Groundwater & Wastewater Services
Septic Project File & Data Review Worksheet

SOIL/SITE EVALUATION
for ON-SITE WASTEWATER SYSTEM

Re: Application for improvement permit for:
Property Location: 15200 Millview Trace Ln.

Health Department File Number: **7034A**

PROPOSED PLOT PLAN

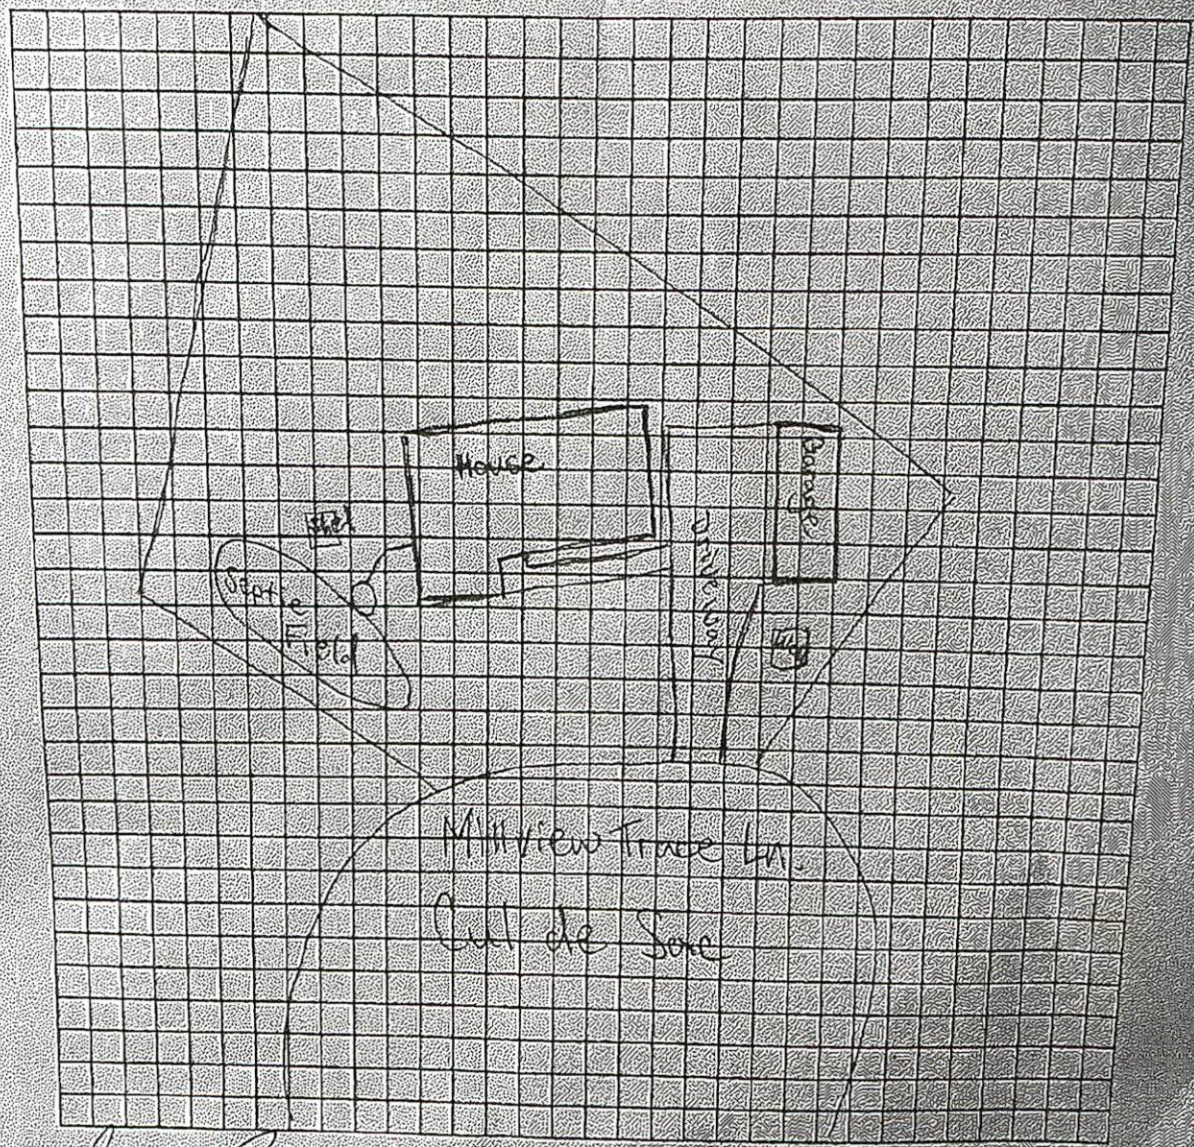
The Mecklenburg County Health Department, Environmental Health Division on June 23, 2020 evaluated the above-referenced property at the site designated on the site plan that accompanied your improvement permit application. According to your application the site which is currently a three-bedroom septic system was to be altered and increased to a four-bedroom septic system., with a daily design flow of 480 gallons per day. The evaluation was done in accordance with the laws and rules governing wastewater systems in North Carolina General Statute 130A-333 and related statutes and Title 15A, Subchapter 18A, of the North Carolina Administrative Code, Rule .1900 and related rules.

Based on the criteria set out in Title 15A, Subchapter 18A, of the North Carolina Administrative Code, Rules .1940 through .1948, the evaluation indicated that the site is **UNSUITABLE** to alter the existing septic system from a three bedroom to a four bedroom absorption sewage system. Therefore, your request for an improvement permit is **DENIED.** A copy of the site evaluation is enclosed. The site is unsuitable based on the following:

- ☐ Unsuitable soil topography and/or landscape position (Rule .1940)
- ☐ Unsuitable soil characteristics (structure or clay mineralogy) (Rule .1941)
- ☒ Unsuitable soil wetness condition (Rule .1942)
- ☐ Unsuitable soil depth (Rule .1943)
- ☐ Presence of restrictive horizon (Rule .1944)
- ☒ Insufficient space for septic system and repair area (Rule .1945)
- ☐ Unsuitable for meeting required setbacks (Rule .1950)
- ☐ Other (Rule .1946)

For the reasons set out above, the property is currently classified **UNSUITABLE,** and an improvement permit shall not be issued for this site in accordance with Rule .1948 (c).

However, the site classified as **UNSUITABLE** may be classified as **PROVISIONALLY SUITABLE** if written documentation is provided that meets the requirements of Rule .1948(d). A copy of this rule is enclosed. You may hire a consultant to assist you if you wish to try to develop a plan under which your site could be reclassified as **PROVISIONALLY SUITABLE.**

Sketch of Soil Evaluation Locations

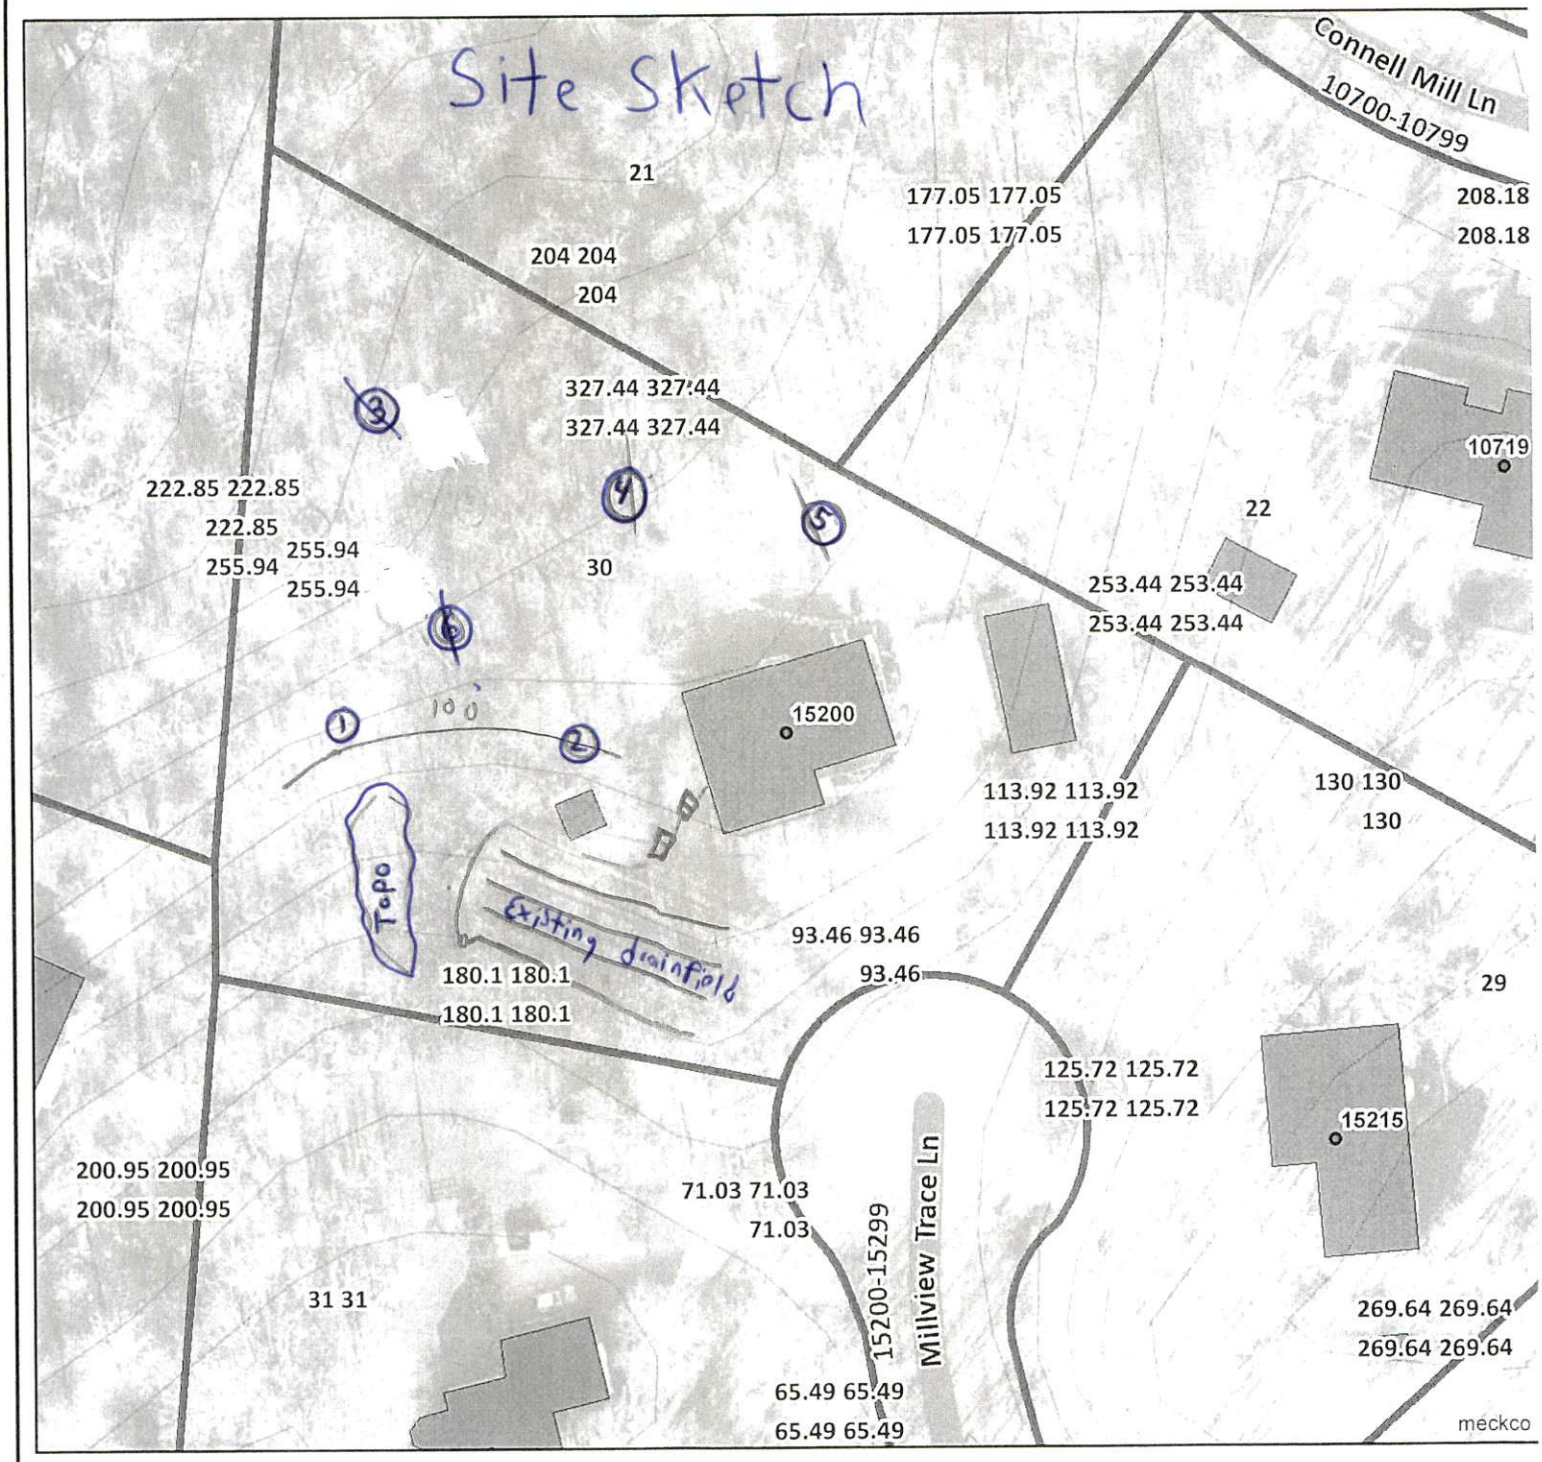
PROFILE #	.1940 Landscape Position/ Slope%	Horizon Depth (IN.)	SOIL MORPHOLOGY .1941 .1941 Structure/ Texture	.1941 Consistence Mineralogy	b PROFILE FACTORS .1942 Soil Wetness/ Color	.1943 Soil Depth (IN.)	.1956 Sapro Class	.1944 Restr Horiz	General Comments	**Profile Class & LTAR**	**Maximum Trench Bottom Depth for 3' Wide Conventional Trench**
Boring #1	LS 2%	0-5	wblk Cl	SS SP FR SEXP	10YR 6/2				Chroma 3 mottles		
		5-25	wblk Scl	S P FR SEXP	27"		NA	NA	begin 24"	**PS .275**	**15"**
		25-27	wblk Cl	SS SP FR SEXP							
Boring #2	LS 2%	0-6"	wblk SICL	SS SP FR SEXP	10YR 6/2				Chroma 3 mottles		
		6-21	wblk SCL	SS SP FR SEXP	29"		NA	NA	begin 25"	**PS 0.275**	**17"**
		21-30	wblk CL	SS SP FR SEXP							
Boring #3	LS 2%	0-13	wblk CL	SS SP FR SEXP	10YR 7/2						
					13"					**U**	
Boring #4	LS 3%	0-15	wblk SIC		10YR 7/2						
					15"					**U**	
Boring #5	LS 3%	0-15	wblk SIC	SS SP FR SEXP	2.5Y 7/2				chroma 3 mottles

15"				begin at 12"	**U**	
Boring #6	LS 5%	0-12	wblk SCL	SS SP FR SEXP	10YR 6/2				chroma 3 mottles		
		12-20	wblk C	SS SP FR SEXP	19"				begin 15"	**U drip**

Description	Initial System	Repair System
Available Space (.1945)	PS	**U**
System Type(s)	III G	**U**
Site LTAR (gpd/sq ft)	**.275**	**U**

*** Soil wetness present throughout property. Therefore, repair area for a four bedroom home could**
